Project
PROPOSED MIXED USE DEVELOPMENT

47-50 THE ESPLANADE ETTALONG BEACH

Drawing Title
**LEVEL 06
FLOOR PLAN**

AMENDED SUBMISSION

1 NORTH ELEVATION
1 : 200

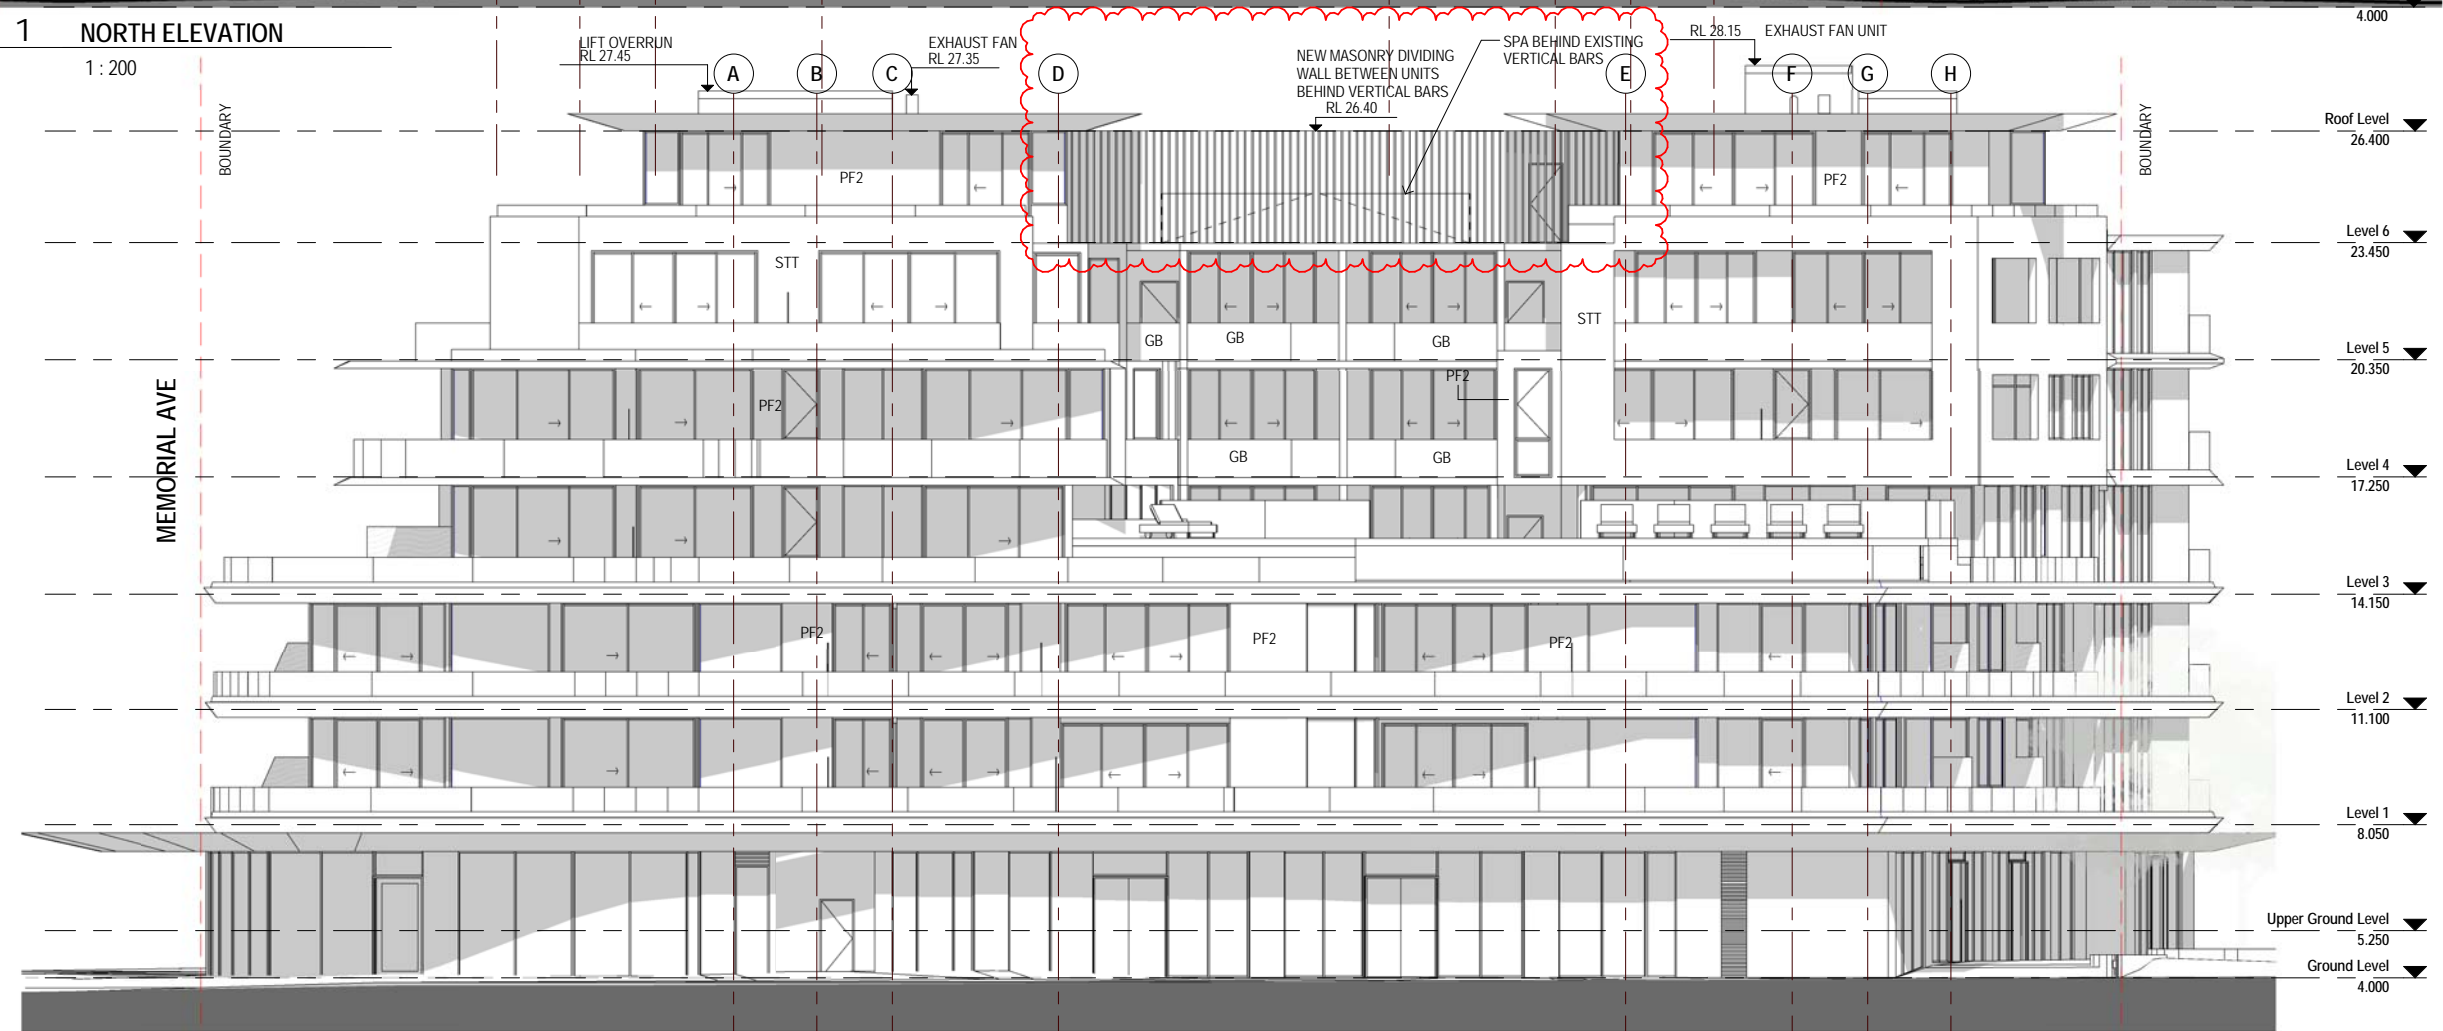
PROPOSED AMENDMENTS:
• LEVEL 6 SOUTH ELEVATION AMENDED TO SHOW NEW DIVIDING WALLS & SPA SHOWN BEHIND EXISTING VERTICAL BARS.

1 PROPOSED LEVEL 6 FLOOR PLAN

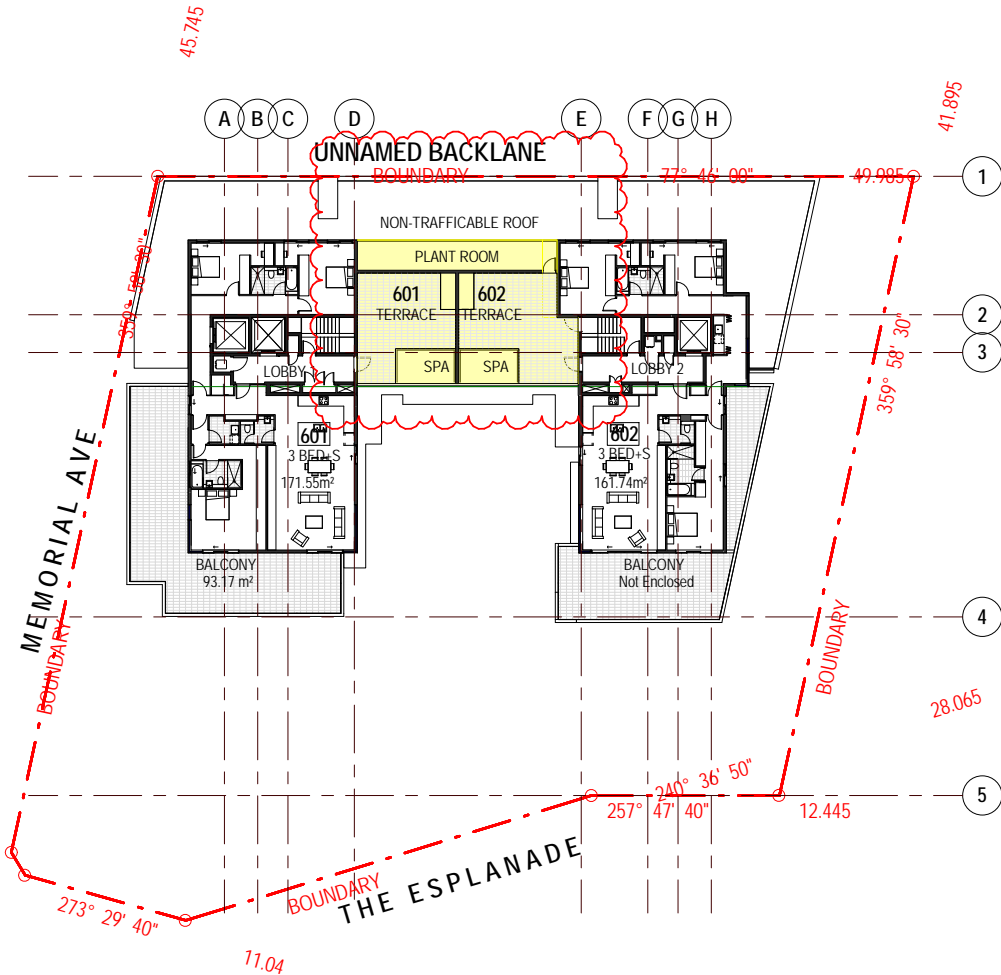
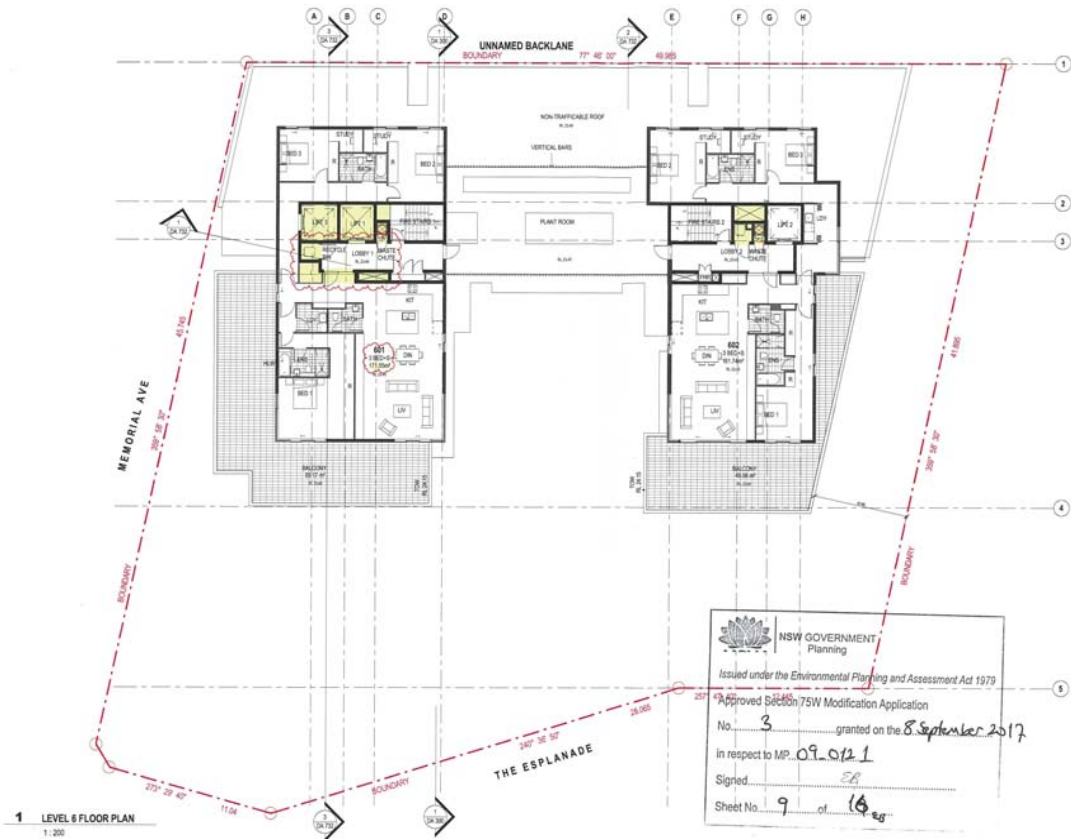
- PLANT ROOM REDUCED.
- OUTDOOR TERRACE AREA PROVIDED FOR UNITS 601 AND 602.
- FREE STANDING SPA + BBQ PROVIDED TO OUTDOOR TERRACE.
- NEW MASONRY DIVIDING WALLS PROVIDED BETWEEN PLANT ROOM AND TERRACES.
- EXISTING VERTICAL BAR SCREEN RELOCATED NORTH.

1 PROPOSED ROOF LEVEL PLAN
1 : 500

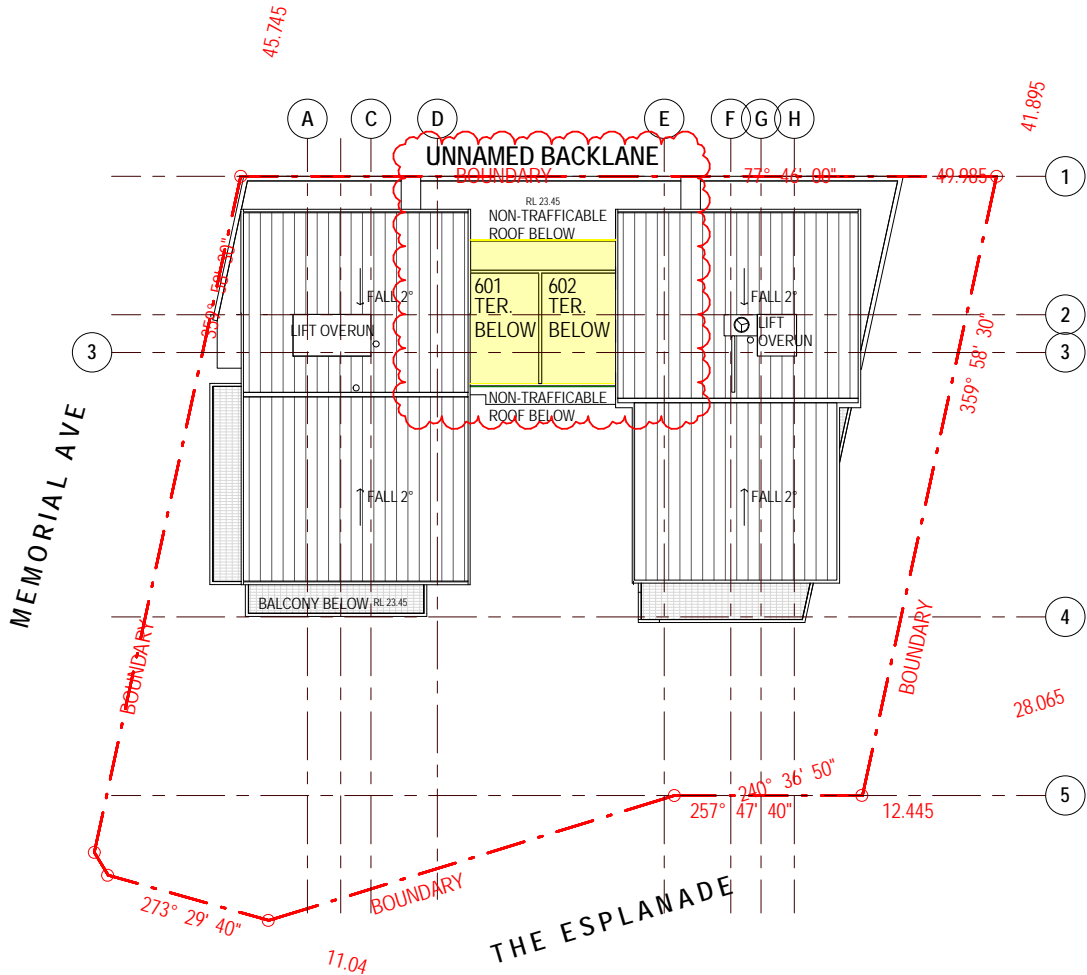
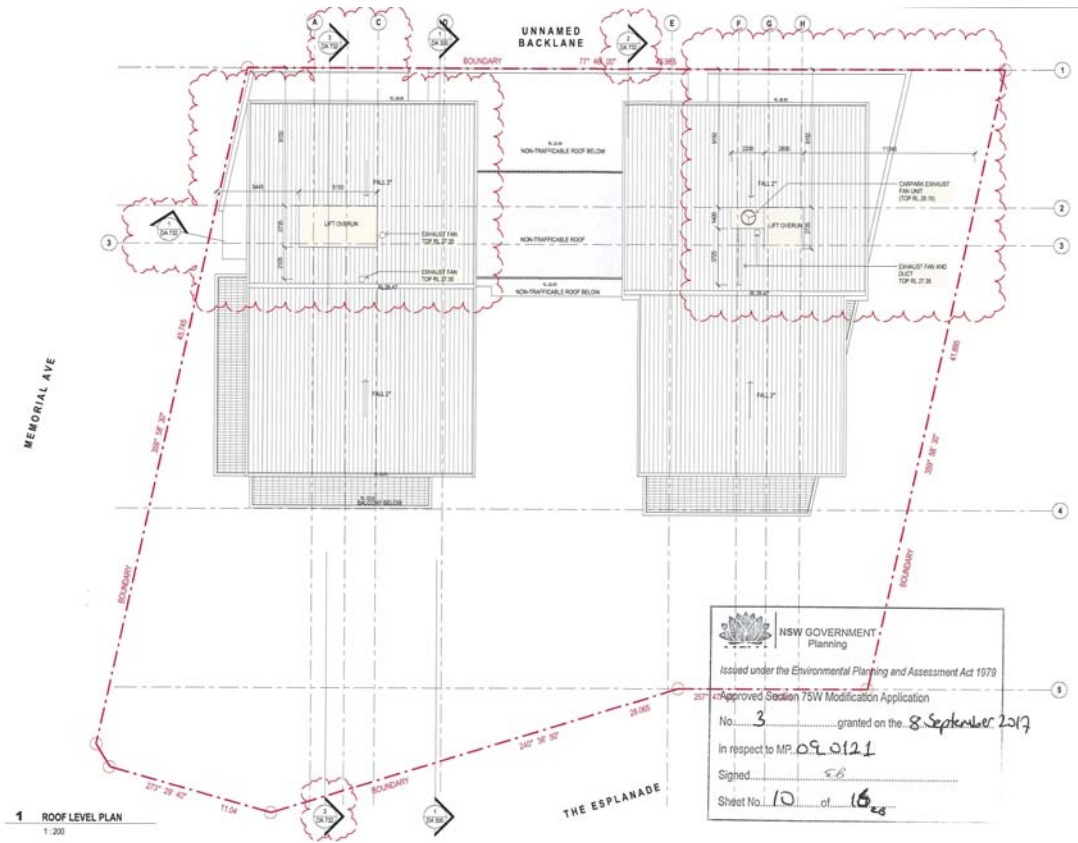
- PROPOSED AMENDMENTS:
- PLANT ROOM REDUCED
 - OUTDOOR TERRACE AREA PROVIDED FOR UNITS 601 AND 602
 - NEW MASONRY DIVIDING WALLS PROVIDED BETWEEN PLANT ROOM AND TERRACES.
 - EXISTING VERTICAL BAR SCREEN RELOCATED NORTH

2 PROPOSED SOUTH ELEVATION
1 : 500

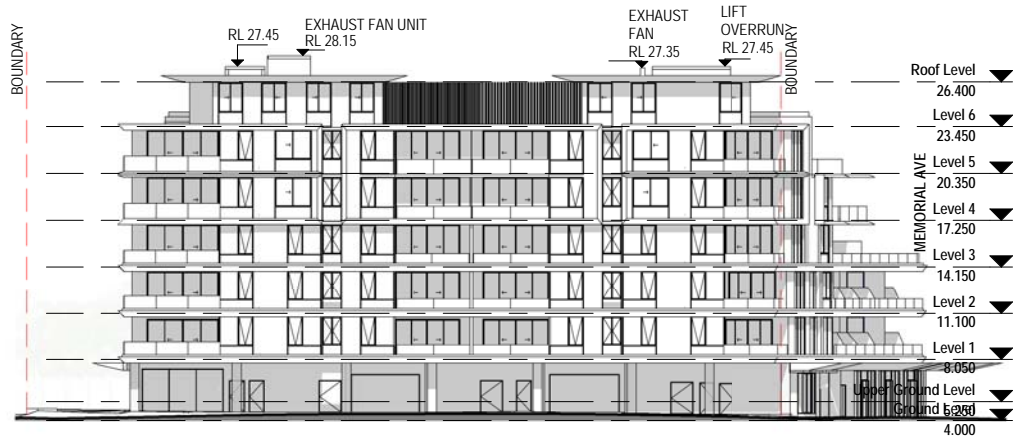
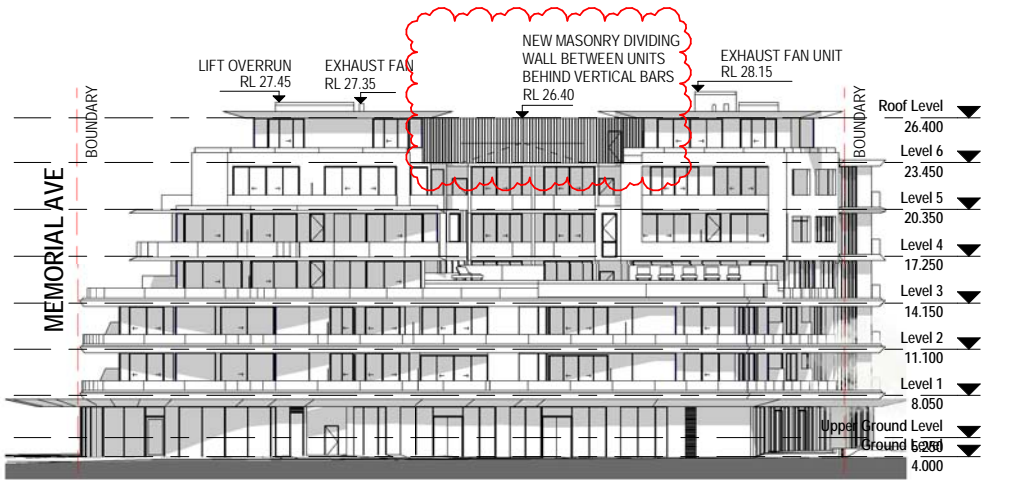
- LEVEL 6 SOUTH ELEVATION AMENDED TO SHOW NEW DIVIDING WALLS & SPA SHOWN BEHIND EXISTING VERTICAL BARS.
